### APPEAL SUMMARY

<b>Appeal ID:</b> 21954	<b>Project Address:</b> 151 SW 1st Ave
<b>Hearing Date:</b> 10/2/19	<b>Appellant Name:</b> Tom Jaleski
<b>Case No.:</b> B-015	<b>Appellant Phone:</b> 9712385266
<b>Appeal Type:</b> Building	<b>Plans Examiner/Inspector:</b> John Cooley
<b>Project Type:</b> commercial	<b>Stories:</b> 5 <b>Occupancy:</b> B, M, S-1 <b>Construction Type:</b> III-A
<b>Building/Business Name:</b> PAE Living Building	<b>Fire Sprinklers:</b> Yes - Throughout
<b>Appeal Involves:</b> Erection of a new structure, Reconsideration of appeal	<b>LUR or Permit Application No.:</b> 19-124284-LU
<b>Plan Submitted Option:</b> pdf [File 1] [File 2] [File 3] [File 4]	<b>Proposed use:</b> Office, Retail

# PAE Living Building

## Engineering Judgment Report #1

Figure 1a. Wall section.

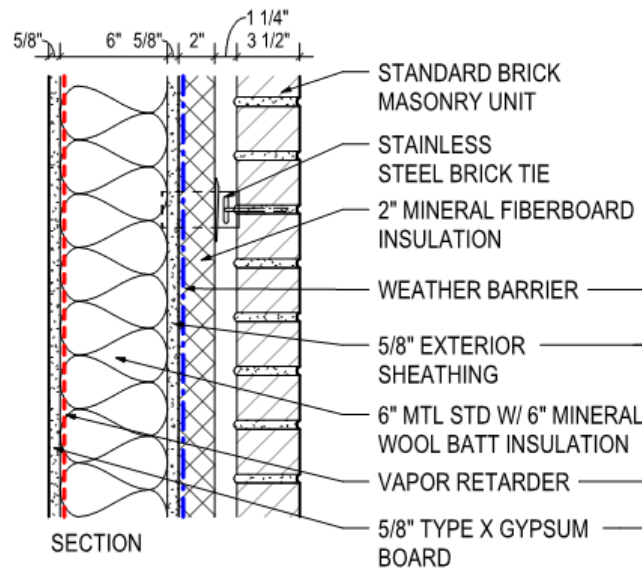
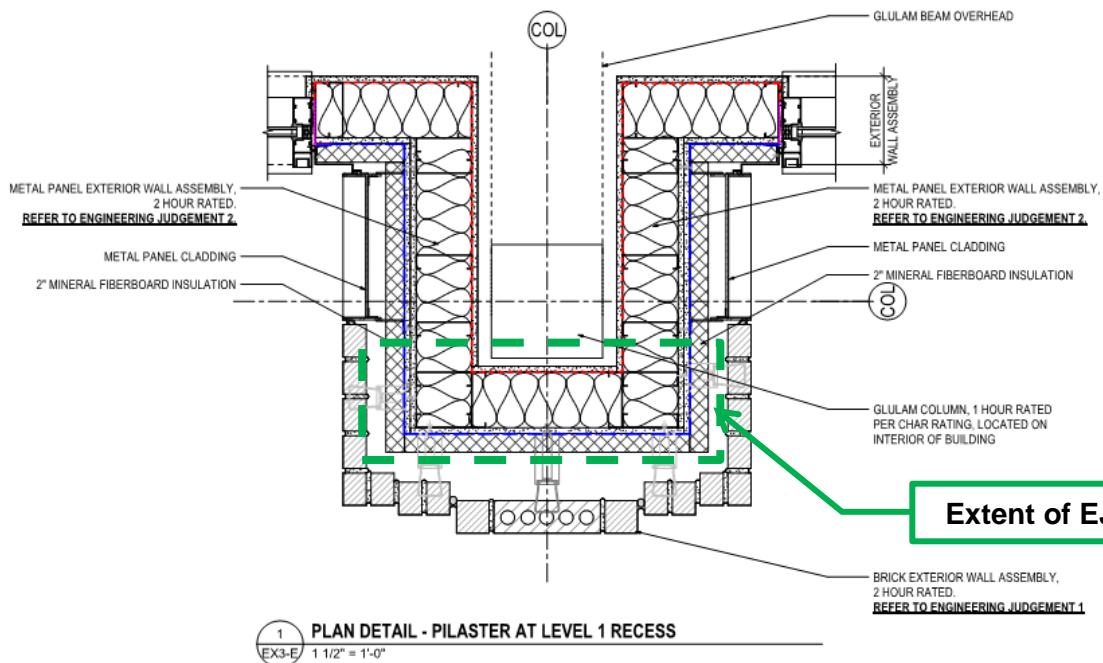
The wall is rated to ensure the columns are afforded 2-hours of additional fire resistance from an assumed fire on the exterior of the wall.

The wall assembly is modified by adding 2-inch non-combustible mineral wool board on the exterior, an air gap and a brick exterior.

The design intent is to meet all the provisions of WP 1350 design as a 1-hour basis. The additional components that are different from those listed in WP 1350 are mineral wool board, and a brick exterior. The wall is a non-loadbearing wall; therefore, the additional weight of the exterior components will not have any noticeable effect on the fire performance of the wall.

The brick infill wall of one layer (4" thick) of brick has an equivalent fire resistive protection of greater than 2 hours. The exterior wall exceeds the 1-hour Tested wall with heavy steel studs positioned 16" on center.

The proposed design will exceed the code request for 2-hour rated non-combustible non-loadbearing wall assembly. The additional components will enhance the structural strength and fire rating significantly.

Figure 1a. Proposed wall assembly (2.5" studs).

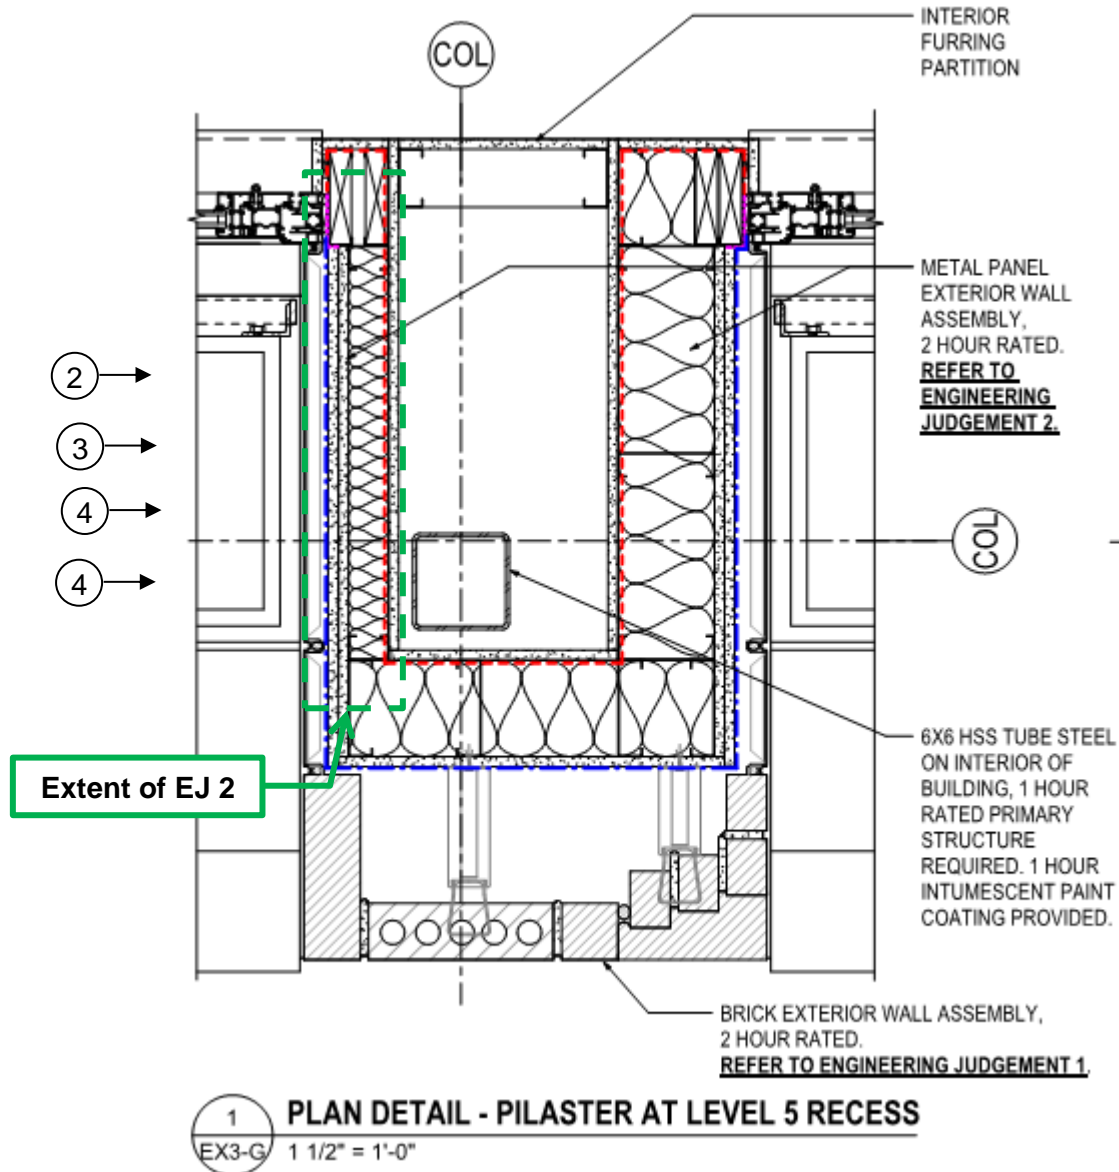
The wall assembly will be 2.5" Steel studs as detailed in Fig. 1a or 6" Steel studs with 2 inch mineral wool fiberboard on the exterior detailed in Fig. 1b.

The design intent is to meet all the minimum provisions of U411 design. The addition components beyond those listed in U411 non-combustible materials. The wall is a non-loadbearing wall; therefore, the additional weight of the exterior components will not have any noticeable effect on the performance of the wall.

The proposed design will exceed the code requirement of 2-hour rated non-loadbearing wall assembly. The proposed steel studs are heavier with closer spacing, supporting a greater fire resistance for the assembly.

Therefore, as detailed above, the proposed exterior wall design will achieve a minimum 2-hour fire-rating when installed to exceed the minimum requirements of UL U411 for an exterior nonloadbearing wall.

Figure 1b. Alternate proposed wall assembly (6" studs with fiberboard)

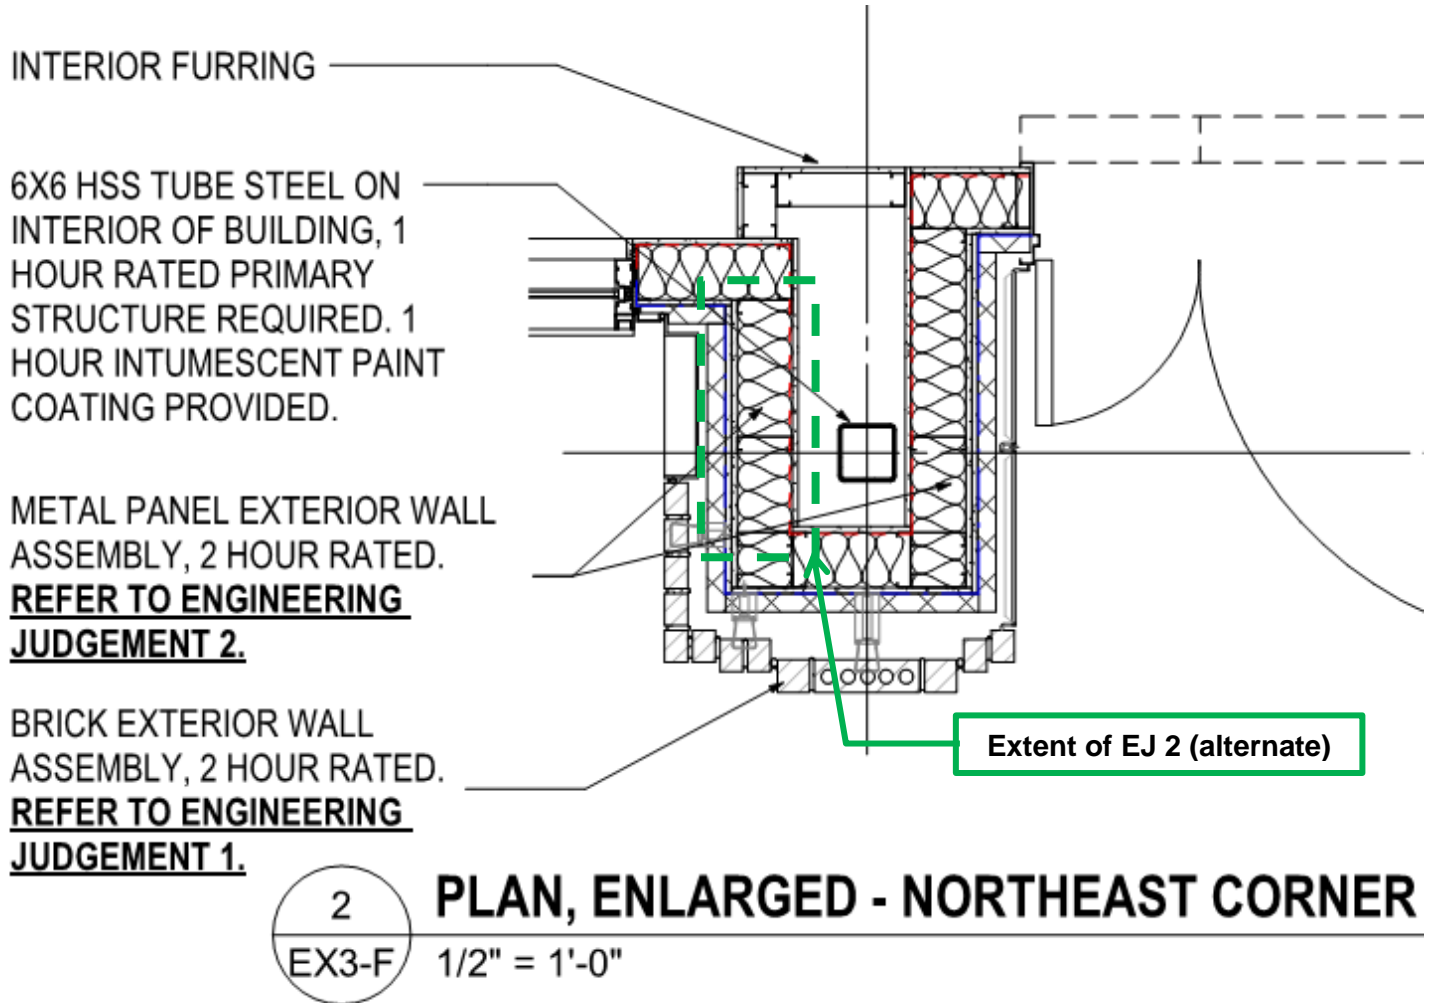
Note: The alternate wall shown in Fig. 1b, utilizes 6" steel studs, providing superior fire rating to the tested assembly with 2.5" Studs.

*Figure 1. Proposed Roof Assembly*

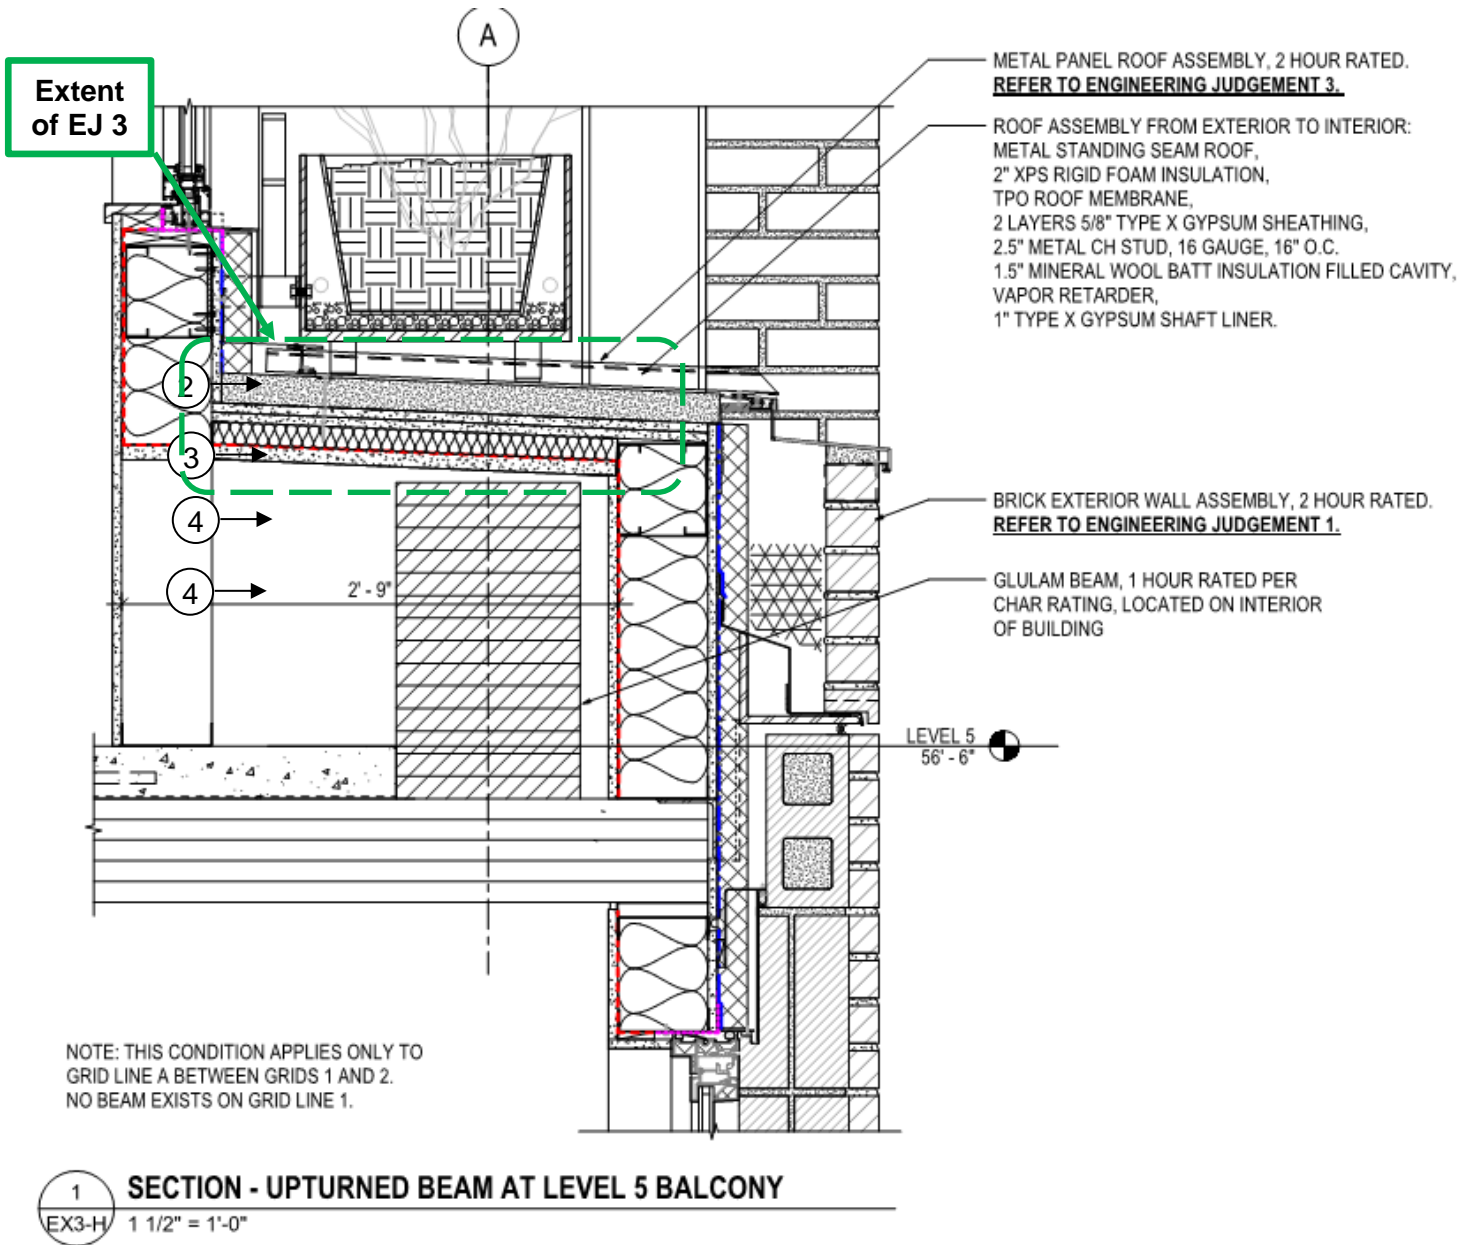
In order to ensure primary structural frame member will be protected at the exterior wall and roof of the floor, the ceiling will be capped by a 2-hour rated ceiling assembly. This ceiling assembly will follow the requirements of NER-258 (Additional, clarifying evaluation, is provided in AER-09038 which details the test requirements of NER-258), and will utilize metal studs at 16" o. c. with two layers of 5/8" Type X on the top and one layer of 1" Type X gypsum shaftliner board on the bottom. Penetrations (if required) will be firestopped with an appropriate fire assembly per OSSC Section 715.

The assembly has been compared to a 2-hour corridor ceiling assembly listed in the NER-258, AER-09038 report, which requires minimum 2-1/2" C-H shaped metal studs at 24" o/c. The proposed assembly exceeds the requirements of figure 9, AER-09038 with 16 Ga members at 16" o/c.

The assembly has been compared to NER 258, which is an ICC legacy report that has been attached. The proposed horizontal ceiling system exceeds the tested system by using:

- 16 ga studs which are much heavier than the tested assembly
- The stud's cavity will be filled with Mineral wool, thereby extending the roof's fire resistance.
- The top of the assembly will utilize an additional 25% GWB, thus creating a more robust fire rating.

The bottom of the ceiling will be protected with 1 layer of 1" Type X GWB, which replaces the ½" Type C tested. An equivalent thickness of Type C is superior for fire endurance, due to its structural core stiffening under higher temperatures. The proposed assembly has compensated for the difference between Type X and Type C by utilizing a single ridged 1" thickness vs the (2) layers of ½" used in the test.

On the upper portion of the assembly, the proposed assembly will replace the 1" Shaft liner with two (2) layers of 5/8" Type X. Two (2) layers of 5/8" Type X can be utilized for two-hour assemblies as shown in Appendix A. The ASTM E119 Test FC 2116, which matches the upper half of our assembly contains 2 layers of 5/8" Type X GWB. The FC 2116 test provides an example for the steel protection within the cavity for the duration of the test. The important consideration for an E119 test is the requirement where the steel member average temperature does not exceed 1100°F.

The roof assembly is equivalent or superior to ICC Legacy Report NER-258, when the comparison includes the additional gypsum board on the upper portion and heavier gauge of the steel studs. As documented above, the assembly meets the minimum requirements of the OSSC for a non-load bearing 2-hr assembly with an assumed fire location for this evaluation from the exterior.
